RE: **Townhome for Jason Buchanan**
1106 Griegos NW
Grading and Drainage Plan
Engineer's Stamp Date: 12/20/18
Hydrology File: F14D058A

RE: Townhome for Jason Buchanan, 1106 Griegos Road, NW, Grading Plan
Hydrology File #F14D058A

**TOWNHOME FOR JASON BUCHANAN
 1106 GRIEGOS RD., NW
 GRADING AND DRAINAGE PLAN**

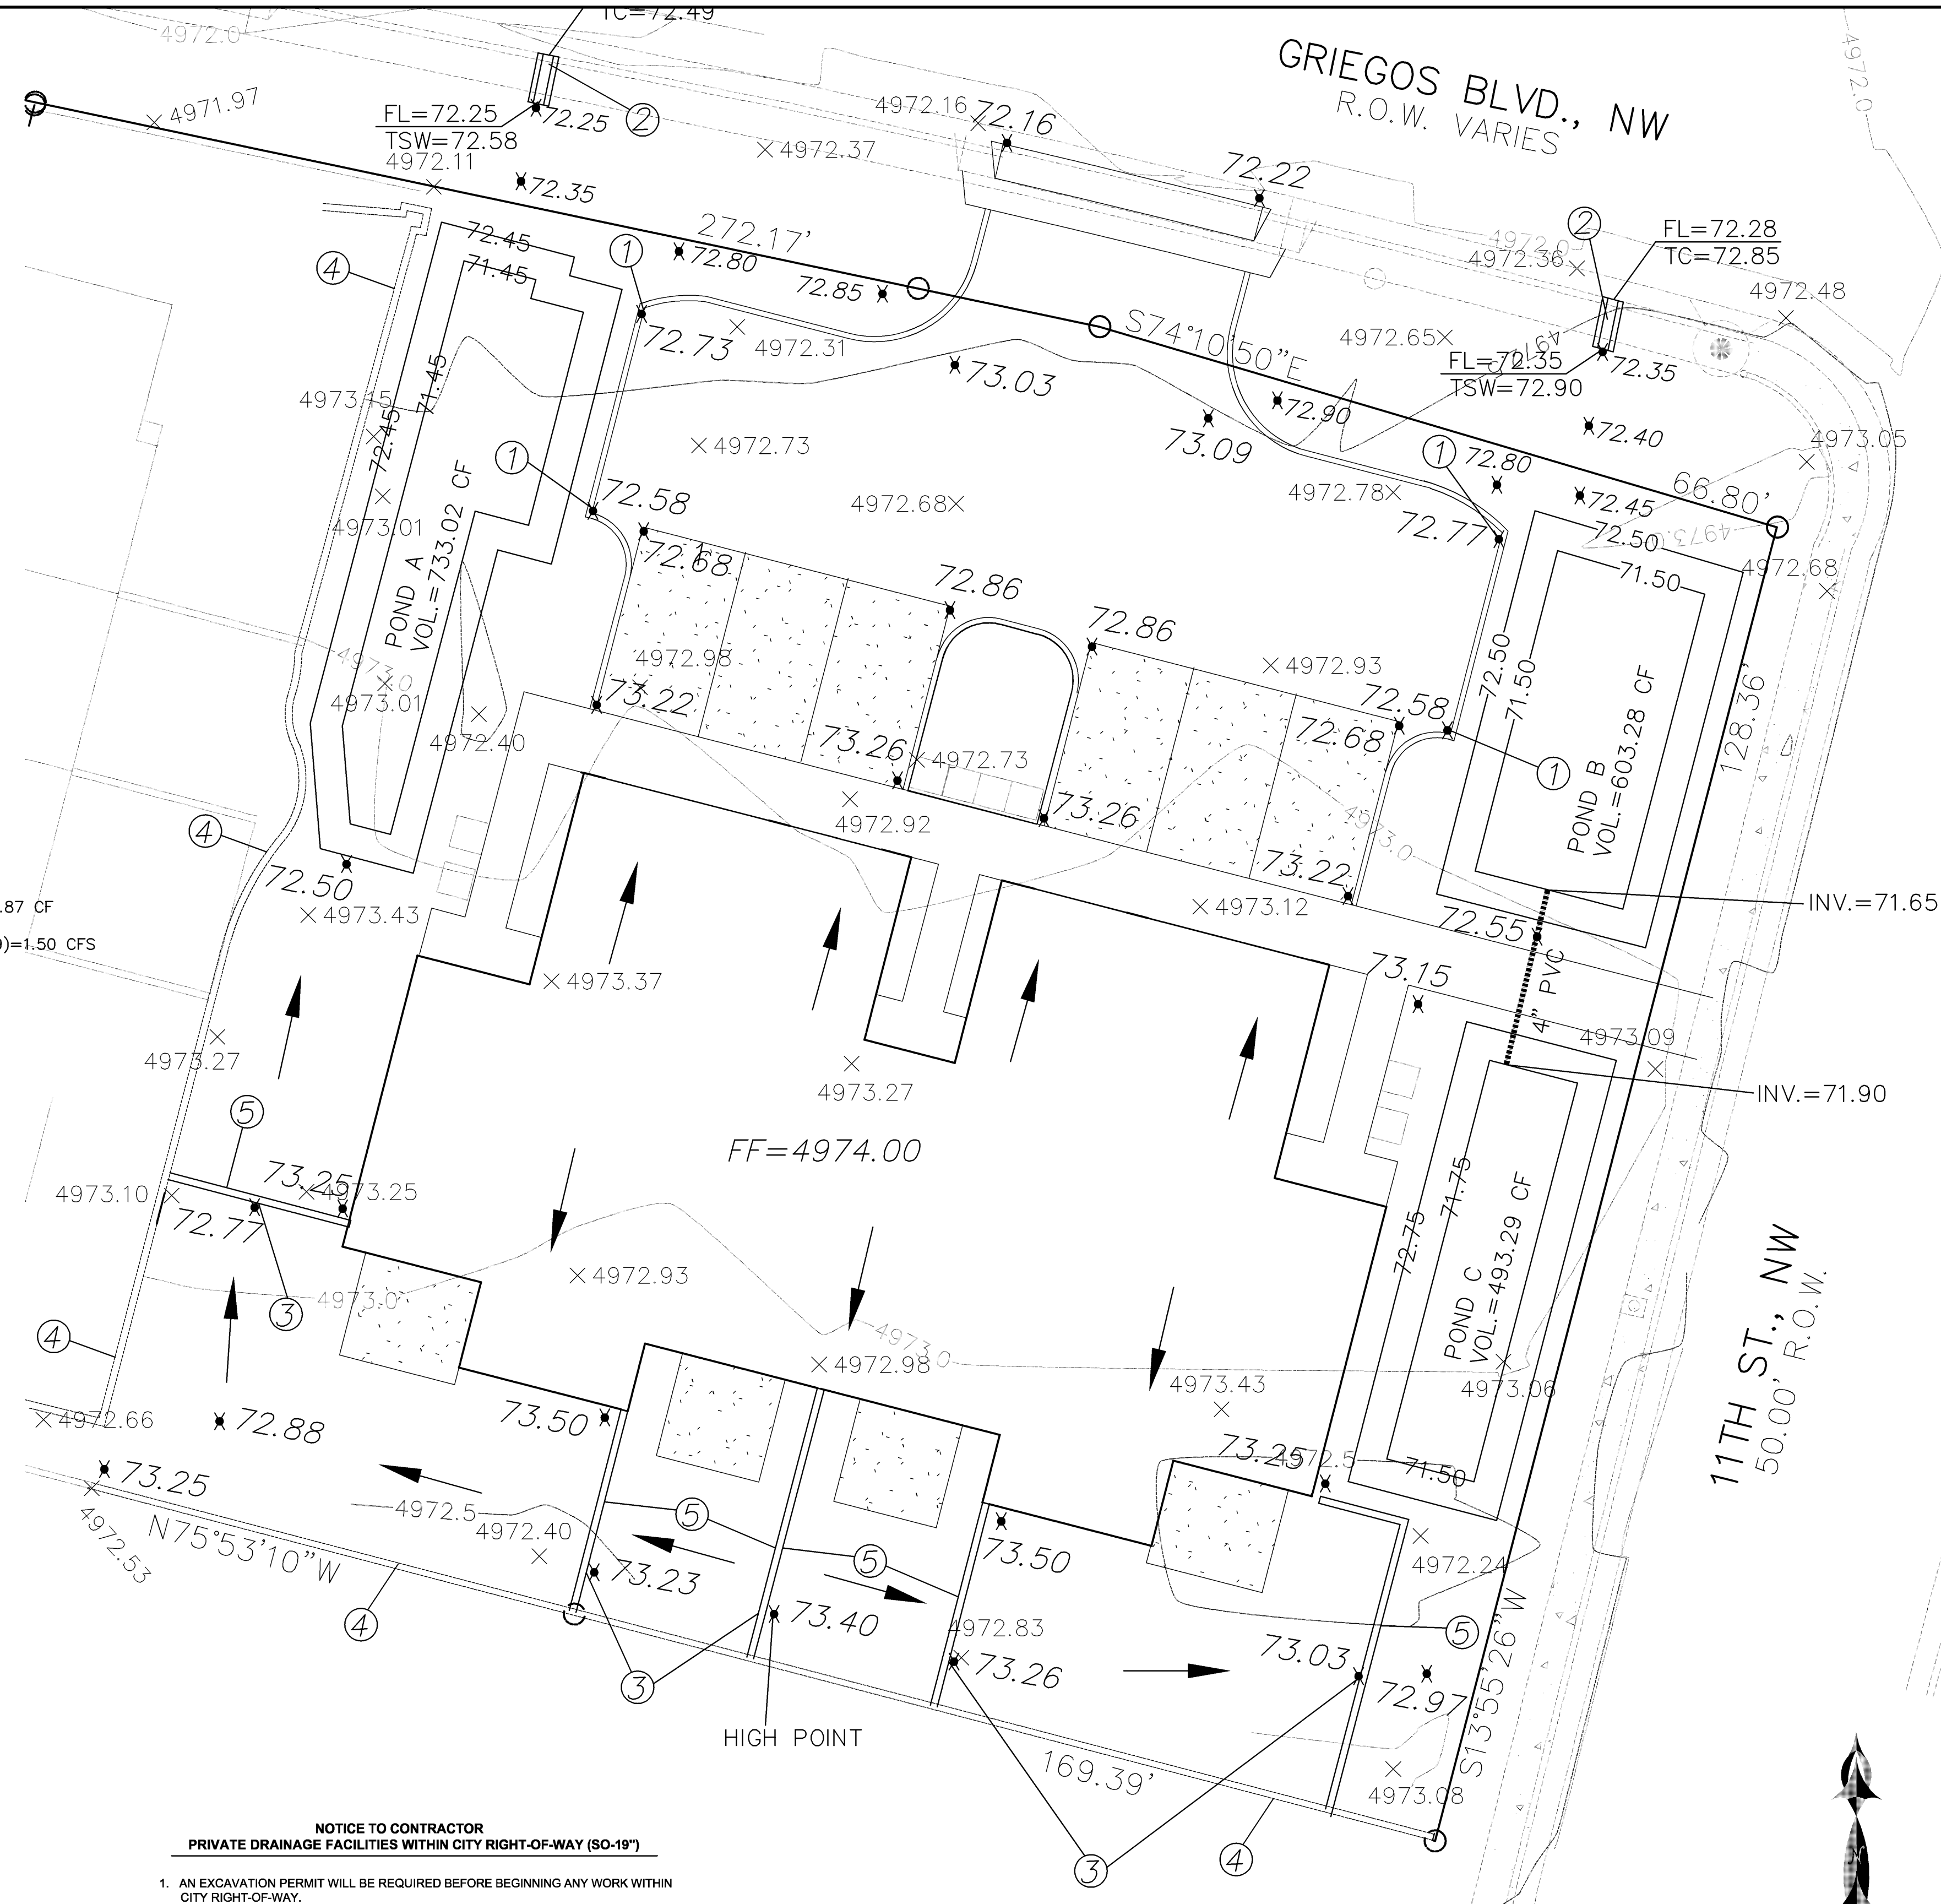
- 1) The grading plan is showing ponding the developed flow under proposed condition minus the historic discharge (for the NW corner of the site only which drains into Griegos, +/-4000 sf).

- 2)The 2.75 cfs/acre discharge is removed from calculations and the onsite ponding of 100-yr, 6hr storm minus historic discharge is shown.
- 3) The reference to AHYMO is removed . It was a wrong sentence under calculations.

- 4) The existing spot elevations are shown on the grading plan.
- 5) The flowline and top of curb elevations are included along Griegos at sidewalk culverts. The 0.87' high water block is shown at the entrance. Some more spot elevation was added to ensure impervious runoff stay on site and will go to the ponds.

- 6) Please see #4 and 5 Under NOTES. These two were added to show existing and proposed walls. Note 4 shows the existing walls and Note 5 shows the proposed.

- 7) The duplicate notice to contractor was deleted from the drawing. I have included the SO-19 notes. I downloaded this from the City website under SO-19. I hope it is the correct note.
